**PARTY SUBMISSION OF  
SOUTHWEST AIRLINES PILOTS' ASSOCIATION  
TO THE NATIONAL TRANSPORTATION SAFETY BOARD**

**SOUTHWEST FLIGHT 278  
KBUR - Burbank, California  
06 December 2018**

**NTSB DCA19IA036**

KBUR Runway 8 with KBUR ASOS and runway 8 SWS locations depicted

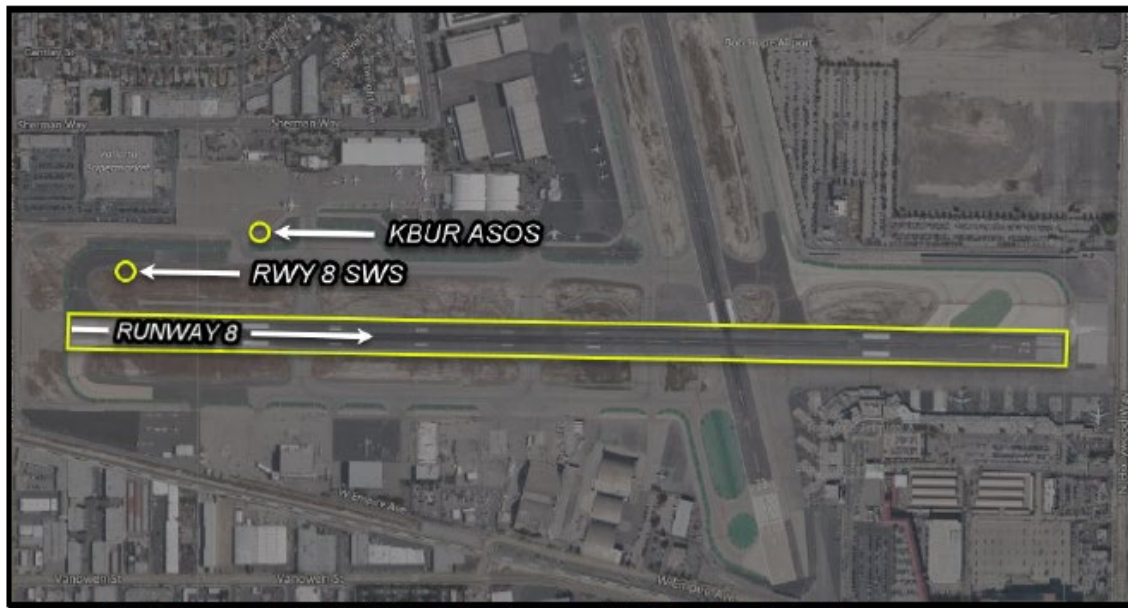
The wind readouts provided to the crew by the controller were from the Surface Weather System (SWS), and differed considerably from those recorded by the Automated Surface Observation System (ASOS), which includes the average 2-minute winds and is updated every 5 seconds. As depicted below, there is an 800’ difference in locations of the ASOS and the runway 08 SWS, with

the SWS located near the beginning of the runway and the ASOS located closer to the actual touchdown zone.<sup>7</sup>

There was a significant difference in wind values between these two independent wind measuring systems. The average 2-minute winds recorded by ASOS were 269/16 at 9:00 and 273/15 at 9:01. At the time of SWA 278's landing, the average 2-minute winds were 279/14 at 9:02 and 282/14 at 9:03, equating to approximately a 14-knot tailwind component.

Importantly, the wind information provided to the crew did not correctly reflect the actual winds. In a tailwind landing situation such as this with winds at or above limits, the crew lacked essential information to determine whether to continue the landing or execute a go around. The crew discussed the winds they were given (270/11), and, at a time-critical moment close to the ground, determined they were within the 10-knot tailwind landing limitation and continued with the landing. While it is true that the tailwind component based on these winds was actually 10.8 knots, had the crew been informed of the actual winds of 279/14, a different analysis and decision would have likely occurred.

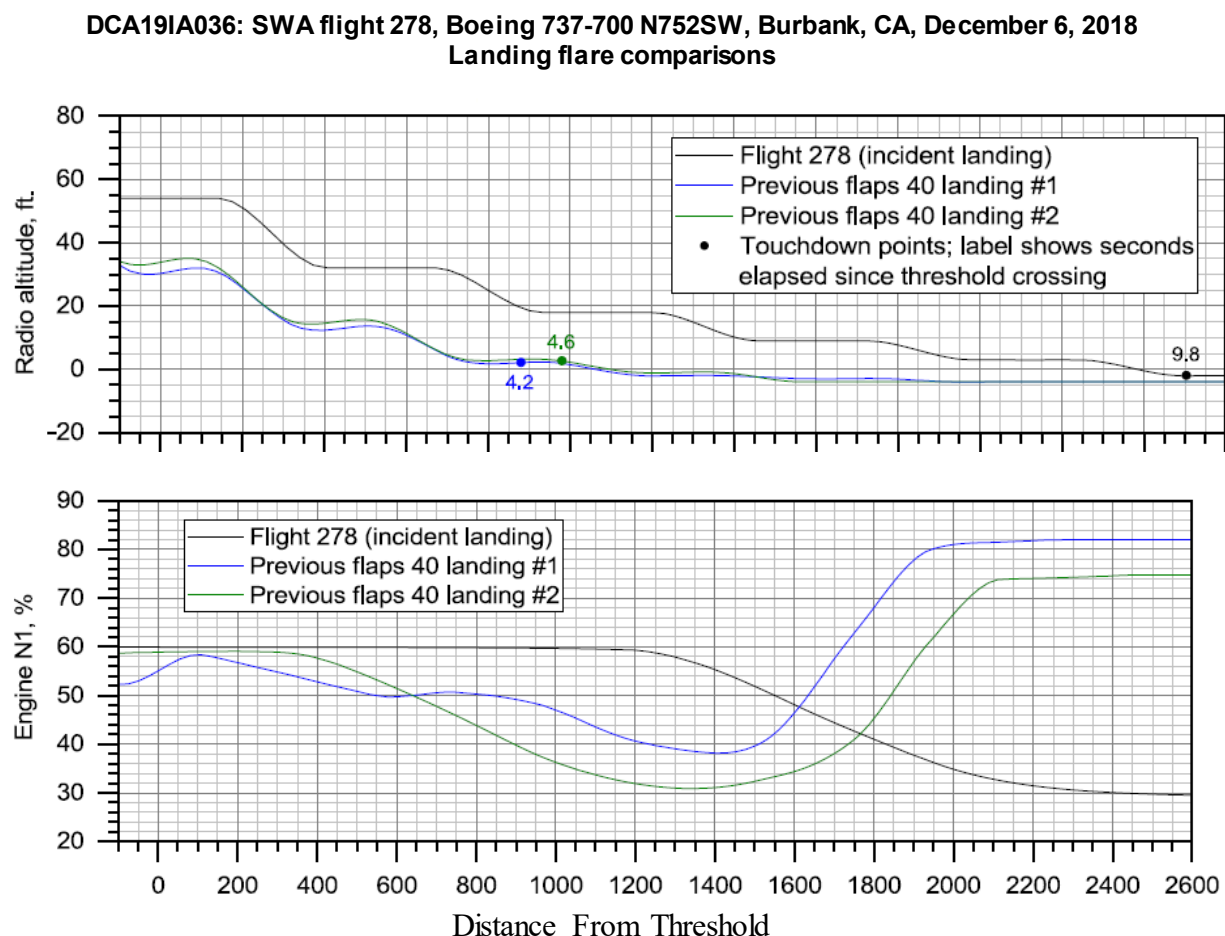
The Study also implies that the pilots were late in reducing power: “In addition, Figure 19 shows that 1,200 feet from the threshold, the engine N1 is only beginning to reduce from 60%. During the previous landings, the engine N1 is reduced below 60% well before the 400 ft. mark.”

The following two graphs are taken from the Performance Study Figure 19 (page 93). To simplify our point, we have reduced the four graphs to two for ease of comparison of “Radio Altimeter,” “N1” and “Distance From Threshold.”

In its analysis of N1 reduction, the Study does not account for the fact that there is no flight deck instrument that alerts the pilots to the distance traveled beyond the threshold, exact threshold crossing height, or time since threshold passage. Pilots do not fly the aircraft based on those parameters; they fly the aircraft based on the parameters they have access to – height above ground, indicated airspeed, sink rate, and thrust. Power is reduced in the flare based on these parameters, not distance or time in seconds from the threshold. A closer review of Figure 19 shows that all crews reduced power at approximately 20 feet. It was the excessive tailwind, unknown/unreported to the crew that caused the late touchdown, not pilot technique or airmanship.

PWB System Landing Data page 1. Source: SWA

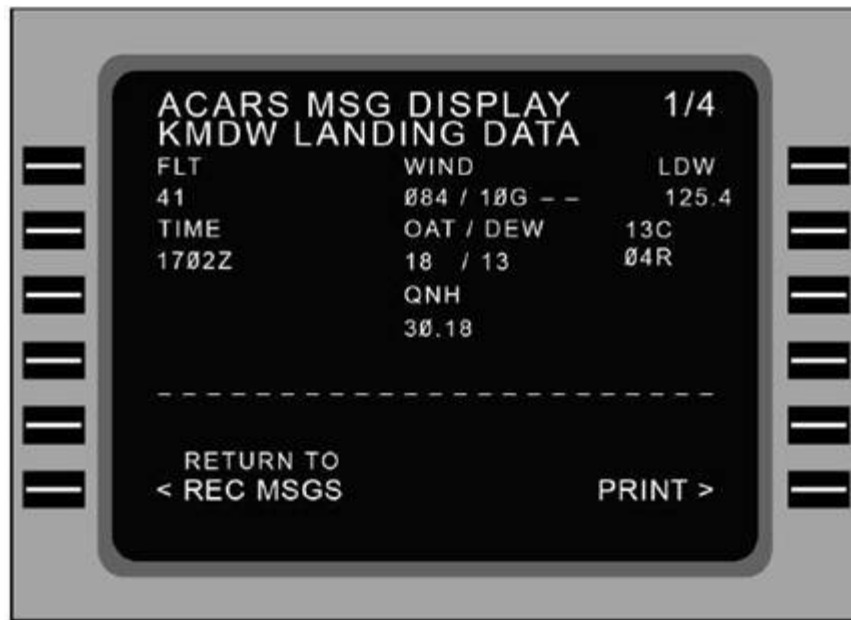
This aircraft also did not have an ACARS printer, although some SWA aircraft are equipped with printers. As can be seen in the figure below, the ACARS installed on the aircraft have a prompt at 6R to print the information on the screen but there is no printer installed on most aircraft.

An ACARS printer can also reduce workload, as the crew does not have to copy down the information for later review. A printed weather report also reduces the possibility for errors in transcription.
